BNSF Energy Management
Human Factors Evaluation
Separate Screen Configuration

Final Report

April 14, 2016

HEURISTIC EVALUATION & COGNITIVE WALKTHROUGH

FIGURE 2: AIR BRAKE NEEDED INDICATION

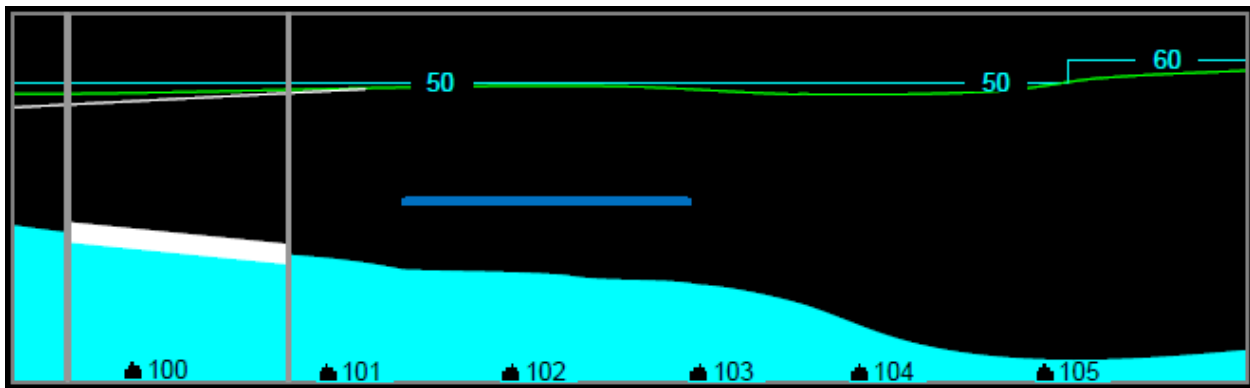
Consider increasing the saliency of the indication by flashing the element.

Its color should not be modified given the historic use of the darker blue for air brake prompting.

FIGURE 3: ROLLING MAP CONTROL MODE INDICATIONS (FROM TO-PTC ON GE LOCOMOTIVE DISPLAY OVERVIEW R1, PG 6)

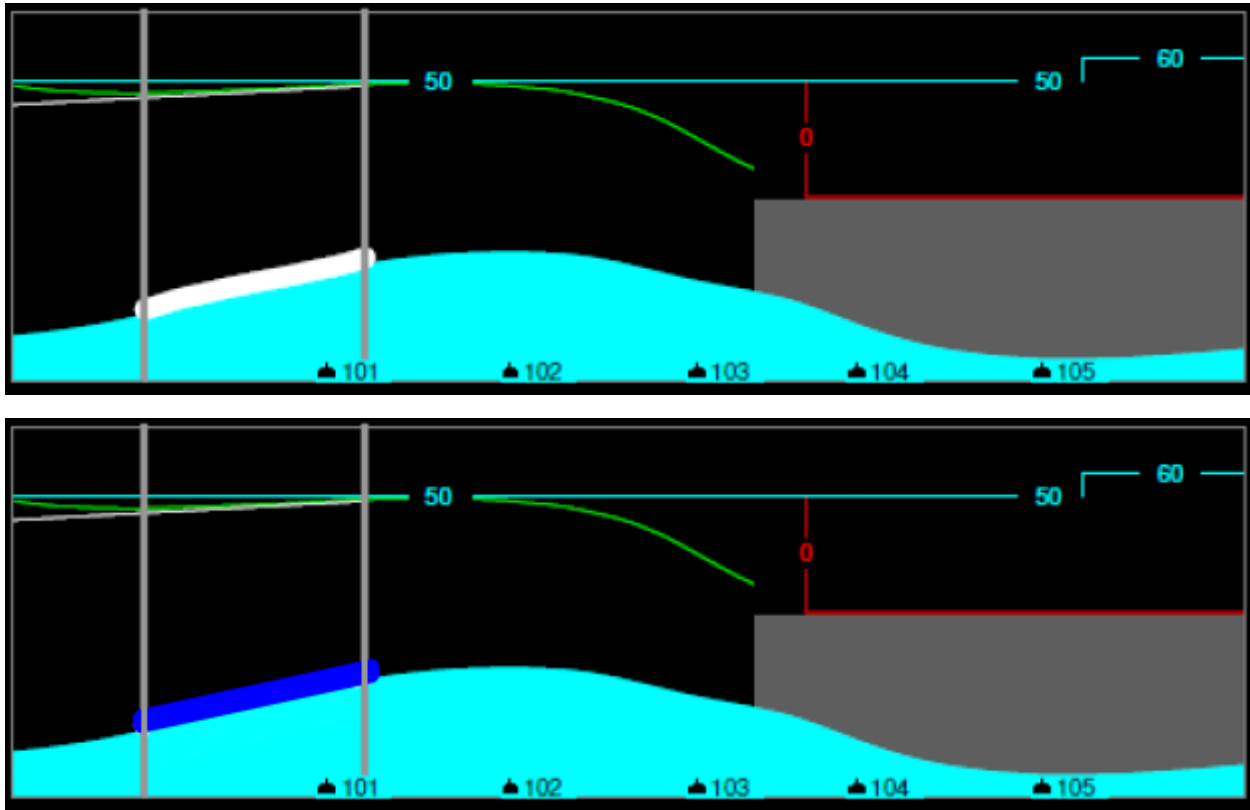
For the TO portion of the screen it is recommended that steps be made to make the control mode immediately apparent by **providing an explicit indication of whether the system is in manual or auto control**; one that is 1) always present, 2) always in the same location, and 3) that allows for an at-a-glance comprehension of system state. For example, altering the appearance of the train, such as coloring the train a different color when in Auto Control would be an ideal indication, as the control mode is directly associated with the train, is always present on screen and always in the same location, eliminating any need to scan for the indication.

Consider the following:

FIGURE 4: CURRENT WORKFLOW (FROM TO-PTC ON GE LOCOMOTIVE DISPLAY OVERVIEW R1)

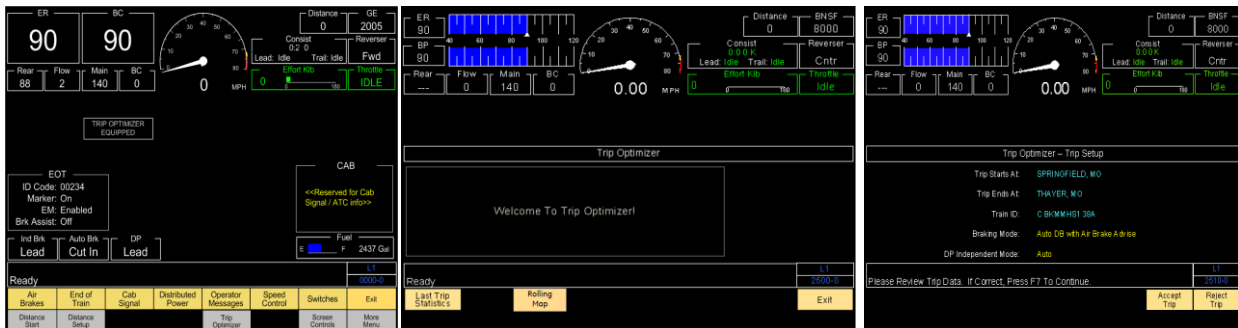
The workflow should be revised to eliminate the Welcome Screen, combine it with the Features Acceptance screen, or alter it to provide value to the user.

The Welcome screen presented when the user presses the Trip Optimizer button from the Main Locomotive Screen (as seen in Figure 4) is unnecessary; it serves to only increase the number of steps the user must go through to start a trip and increases the amount of time that the user is away from the AAR screen.

There is no unique information provided by the Welcome screen. The only options are to Exit, should the user have entered this screen by mistake, to access the Last Trip Statistics, and to press Start TO PTC Trip or New Trip (with PTC and in Standalone, respectively), which accesses the Features Acceptance screen for the current trip.

FIGURE 5 PROPOSED FEATURES ACCEPTANCE SCREEN (A – TRIP AVAILABLE / B – TRIP NOT AVAILABLE)

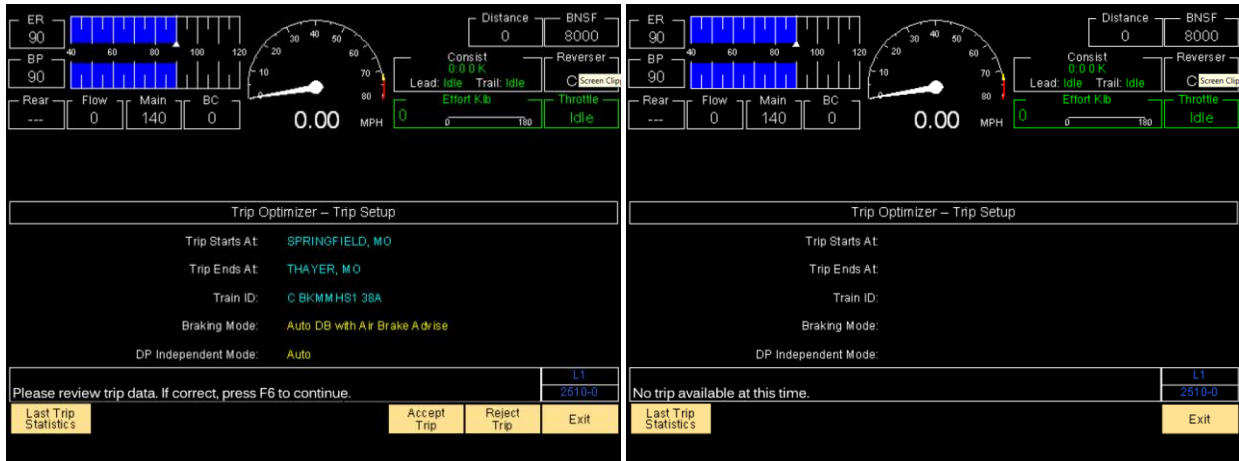
The most frequent action in this screen will be to immediately press Start TO PTC Trip\New Trip to start Trip Optimizer; therefore that workflow should be expedited, which would be accomplished by eliminating the Welcome Screen or combining the Welcome Screen and the Features Acceptance screen, as seen below:

Should a trip not be available the Trip Setup area should be blank, a note indicating this should be provided in the Operator Messages area, and the Accept and Reject Trip buttons should be removed or grayed out). However, this reviewer questions the ability of the engineer to access the Welcome screen when a trip cannot be started (see 4.1.6 Access to TO).

Note that if the user rejects the trip, the current implementation presents a confirmation message and then returns to the Welcome Screen. Eliminating the Welcome screen or combining screens would necessitate that rejecting the trip also exit TO, a fact that would need to be added to the rejection confirmation (e.g. "Are you sure you want to reject the trip and exit Trip Optimizer?").

FIGURE 7: COLOR DEFICIENCY COMPARISON³

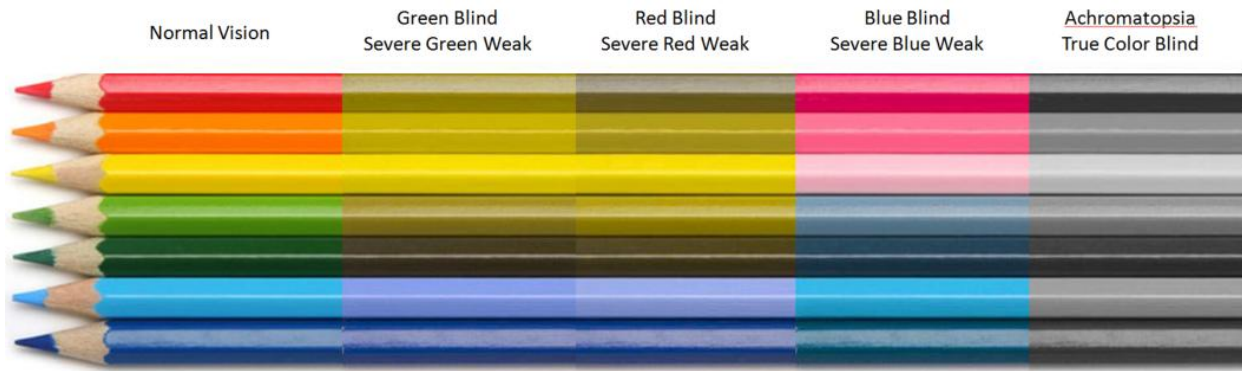
While this meets cultural expectations of color assignment, it does not meet the requirement from Appendix E f10 – “Design all visual displays to meet human performance criteria under monochrome conditions ... and use color coding as a redundant coding technique”.

Users with a red or green color deficiency will have difficulty detecting the change in the border color, as should be apparent from the reference image below (compare the green and yellow pencils for normal vision versus green or red blind/weak)

It is recommended that another change be made to the border to distinguish between motoring and dynamic braking, such as a dashed border, a double border, or a border with a noticeably different thickness.

FIGURE 8: ROLLING MAP (FROM TO-PTC ON GE LOCOMOTIVE DISPLAY OVERVIEW R1, PG 6)

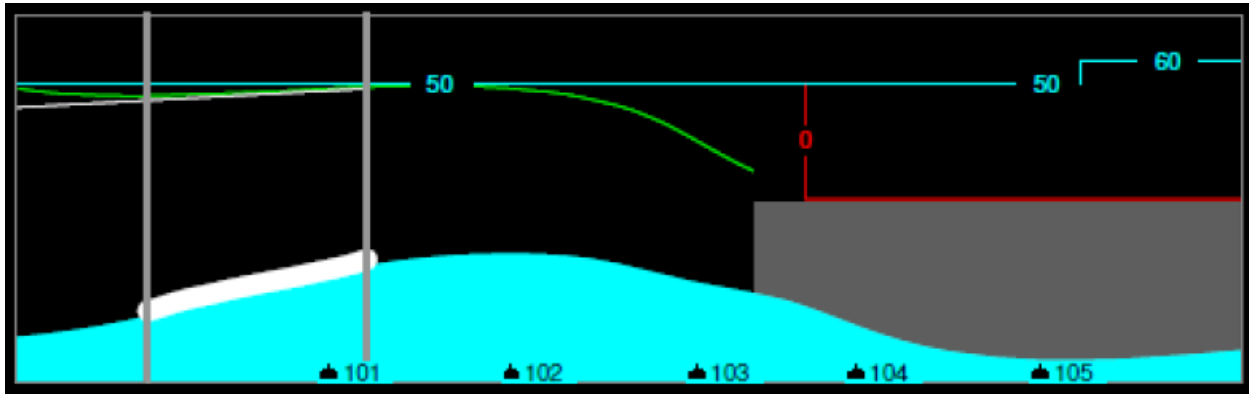
For locations on that map that are at or behind the head-end of the train, the planned speed (green), train speed (white), and track speed (cyan) will likely cluster closely together. In the examples seen by this reviewer, there is little contrast between these lines, making it difficult to determine which is which. Note that the same issue is reduced ahead of the train, given that the train speed (white) is not shown.

Moreover, individuals with color deficiencies will have greater difficulty differentiating these lines (see Figure 7: Color Deficiency Comparison). For those with red or green deficiencies, which are the most common, the red, yellow, and green lines will appear to be various shades of yellow. For those with a blue deficiency (more rare), yellow will appear as a shade of pink and green will be shifted towards cyan.

However, it is recommended that a different format of line should be used to represent one of these speeds. Providing a dashed line (- - -) will allow the user to differentiate the lines without relying on color or curve a key. The most likely candidate to reformat would be planned speed (green) to alleviate this issue both behind and ahead of the train.

Alternatively, consider removing the planned speed line behind the head-end. The value of the line behind the train is questionable, as it provides only feedback regarding how well the train’s actual speed matched the planned speed.

Resolution: The intent is not for the user to examine any particular line, but to examine the closeness of the lines as a means of determining the achieved plan. Therefore this issue is retracted.

FIGURE 9: SPEED (FROM TO-PTC ON GE LOCOMOTIVE DISPLAY OVERVIEW R1, PG 6)

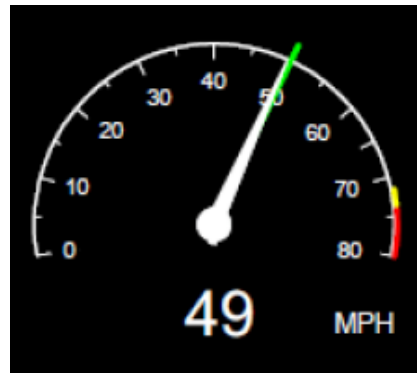
The salience of the plan speed needle within the speed dial will be very low when the plan and actual speeds are close to one another. While this appears to be an issue in the static screens provided in the *TO-PTC on GE Locomotive Display Overview* document, this may not be an issue in the actual use of the system given a dynamic system, which will show the actual speed and plan speed needles moving independently.

However, it should be noted that for those with red or green color weakness or blindness, this plan speed needle will appear shifted towards a dim yellow color (see Figure 7: Color Deficiency Comparison).

Resolution: The intent is not for the user to examine the plan speed needle as a separate visual element, but to observe the closeness of the needles as a means of determine the achieved plan. Therefore this issue is retracted.

FIGURE 1: AAR STYLE CONTROL STAND, C4 & ES44AC/DC AAR DISPLAY – VIEWING ANGLE

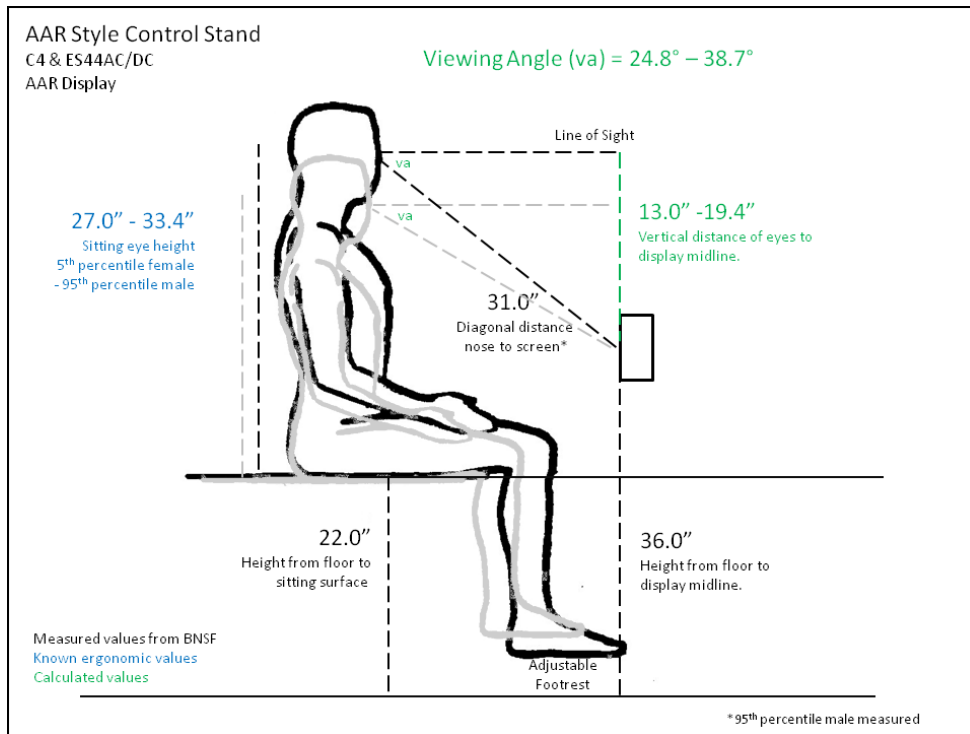
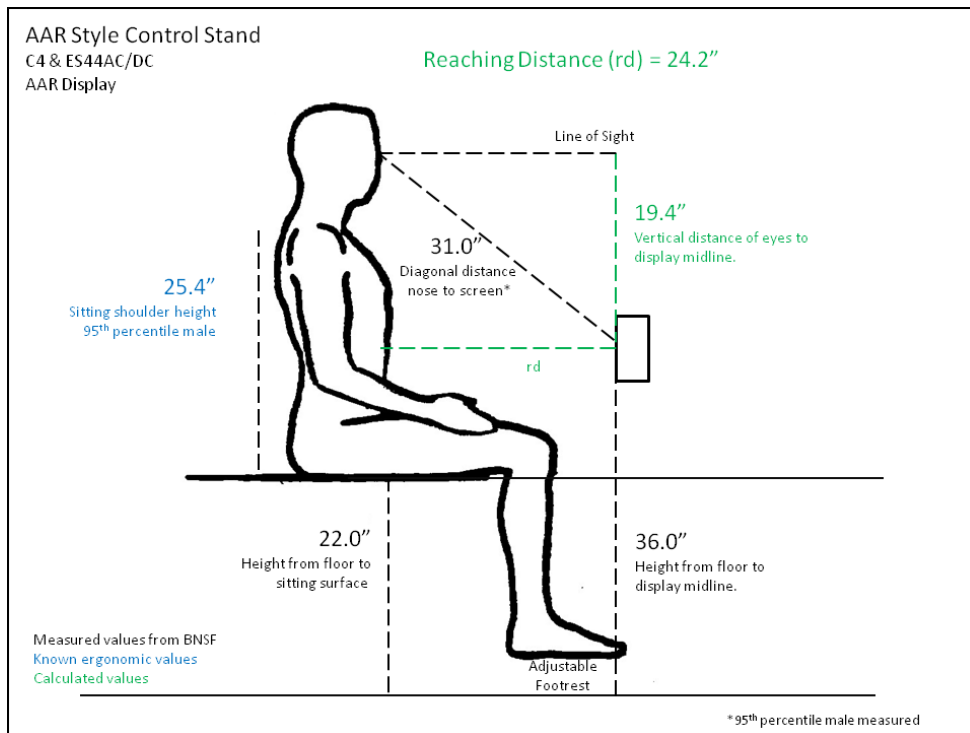
For the AAR implementation of EM, from an ergonomic perspective, the position of the AAR screens is ideal in terms of viewing the displays. They are well within the field of view of the operator and are in the line of sight out the front windshield without obstructing the view out the windshield or of other equipment.

The push buttons to respond to and control the EM features on the AAR screens exceed the normal reach envelope, but reside within the extended reach envelope and are well below shoulder height for even small operators. Given that physical interactions with the AAR screens, as related to EM, will be infrequent while the train is in motion, this is acceptable.

FIGURE 1: AAR STYLE CONTROL STAND, ES₄₄AC/DC CDU DISPLAY - VIEWING ANGLE

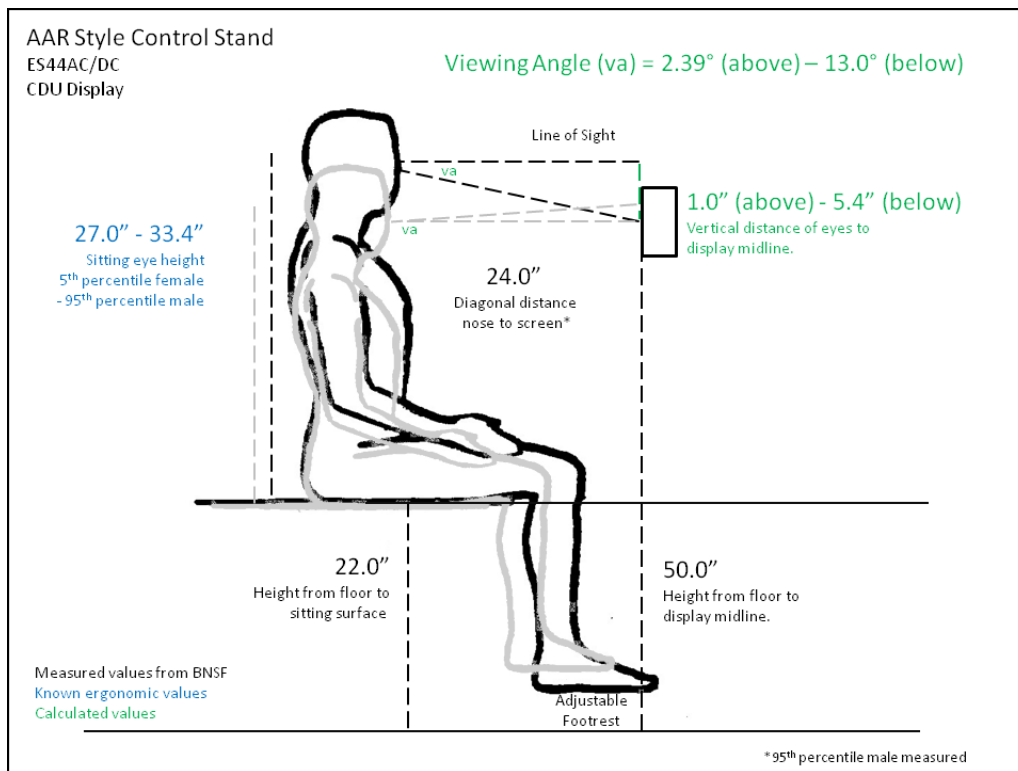
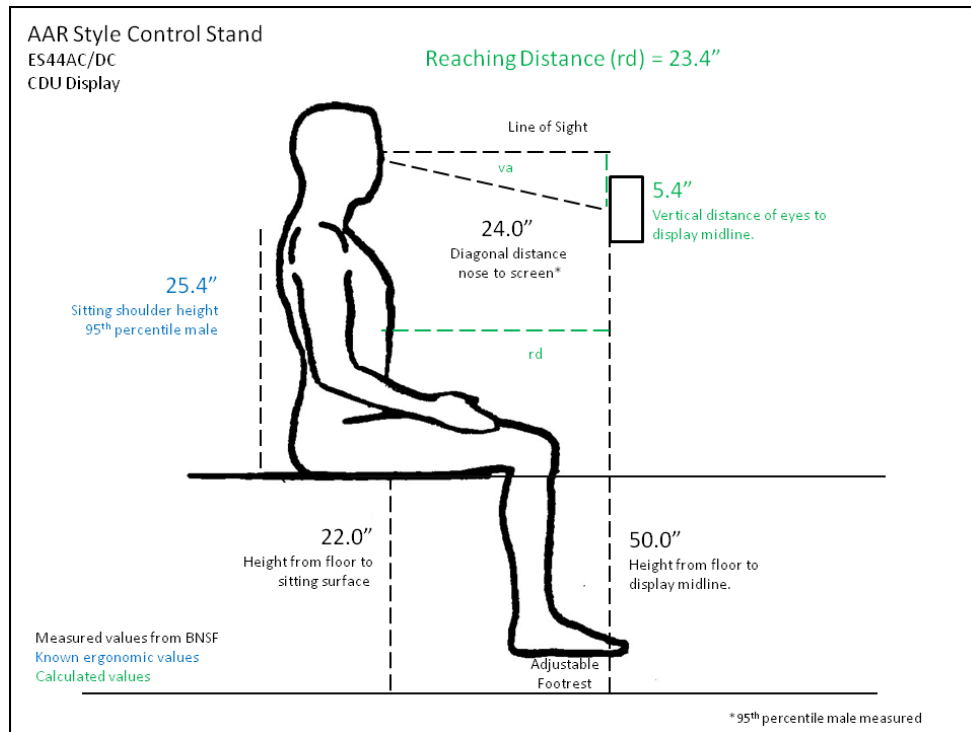
For implementation in which the EM is integrated into the PTC display, the CDU location is less than ideal, given its position to the side of the operator (discussed below).
